UNITED STATES
NUCLEAR REGULATORY COMMISSION
WASHINGTON, D. C. 20555
July 9, 1981

SUBJECT: SEP REVIEW TOPICS II-4, GEOLOGY AND SEISMOLOGY AND II-4.B,
PROXIMITY OF CAPABLE TECTONIC STRUCTURES IN PLANT VICINITY

SEP SAFETY TOPIC EVALUATION
R. E. GINNA NUCLEAR POWER PLANT

TOPIC II-4, GEOLOGY AND SEISMOLOGY

Ginna Site
(5% Damping)

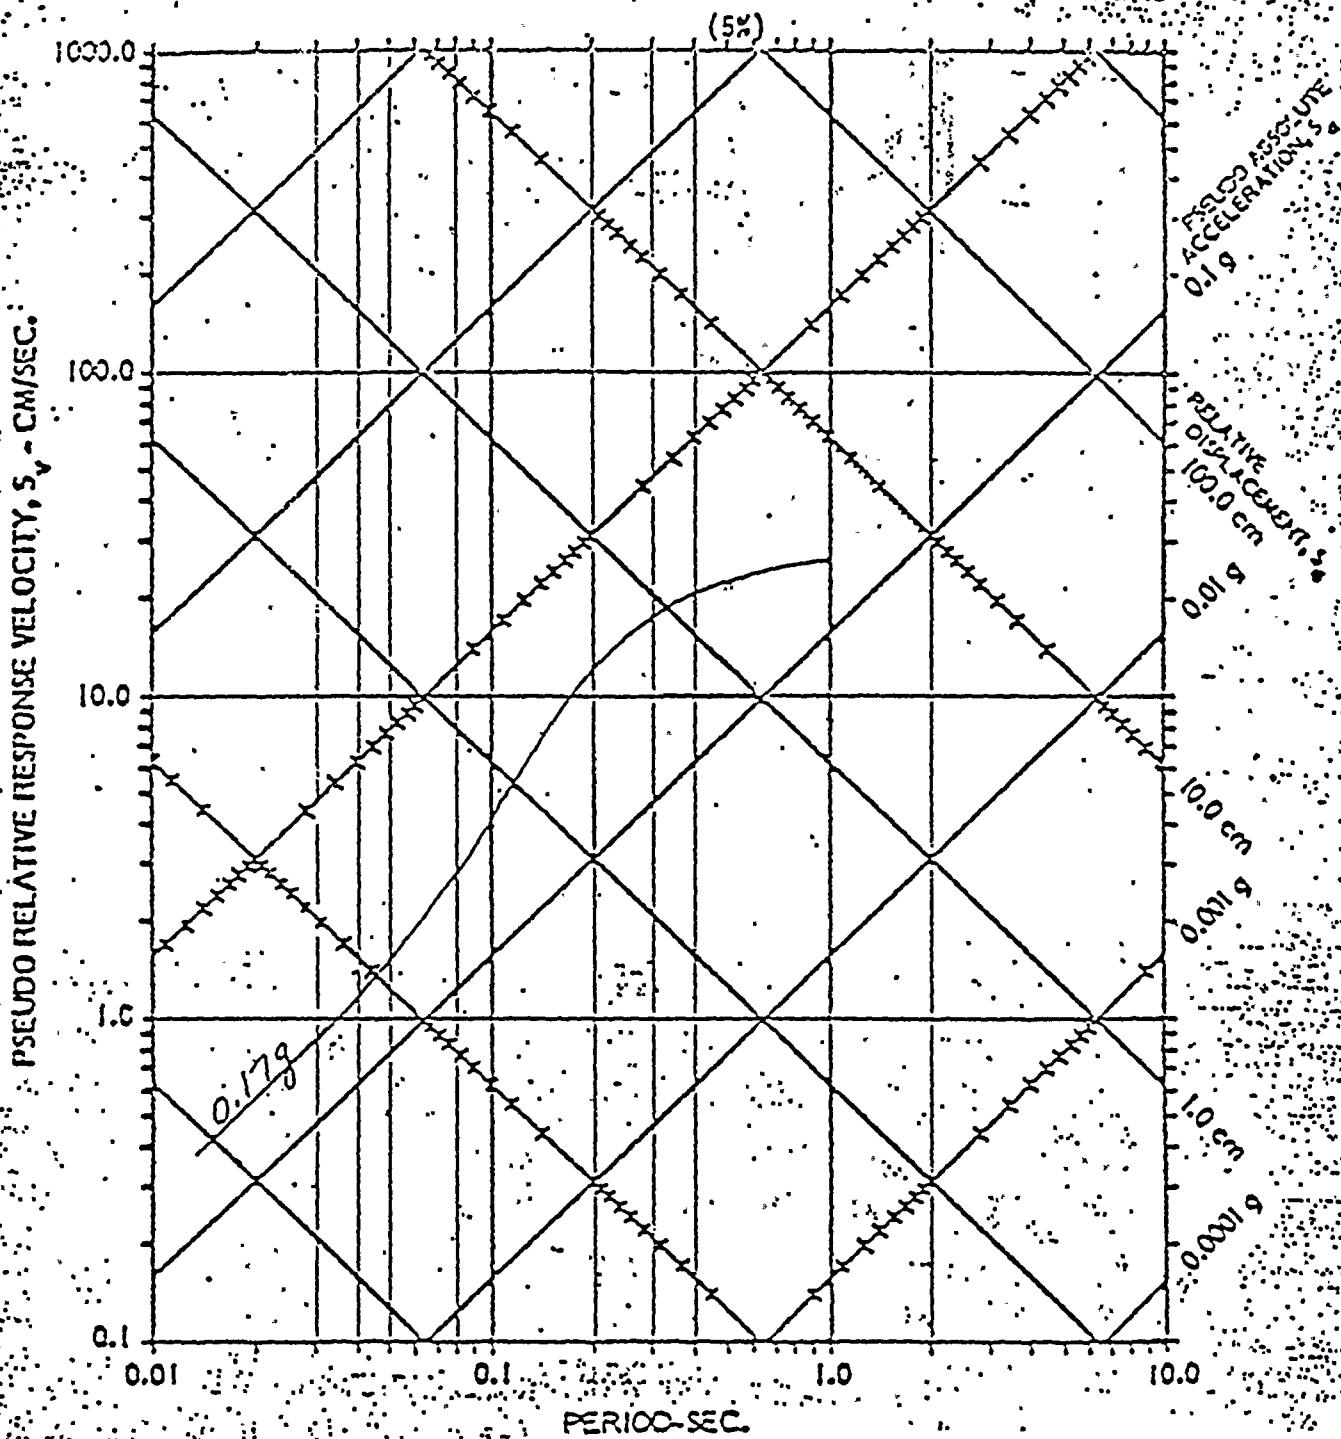
Our letter dated August 4, 1980 (reference) issued the preliminary version of site specific ground response spectra for the eastern United States SEP plants. Recently, these spectra have been finalized by the staff. Enclosure 1 includes the recommended ground response spectra (5% damping) for the eastern SEP sites. The bases of our final decision regarding the spectra and the digitized spectral acceleration values (5% damping) for these spectra are documented in Enclosure 2.
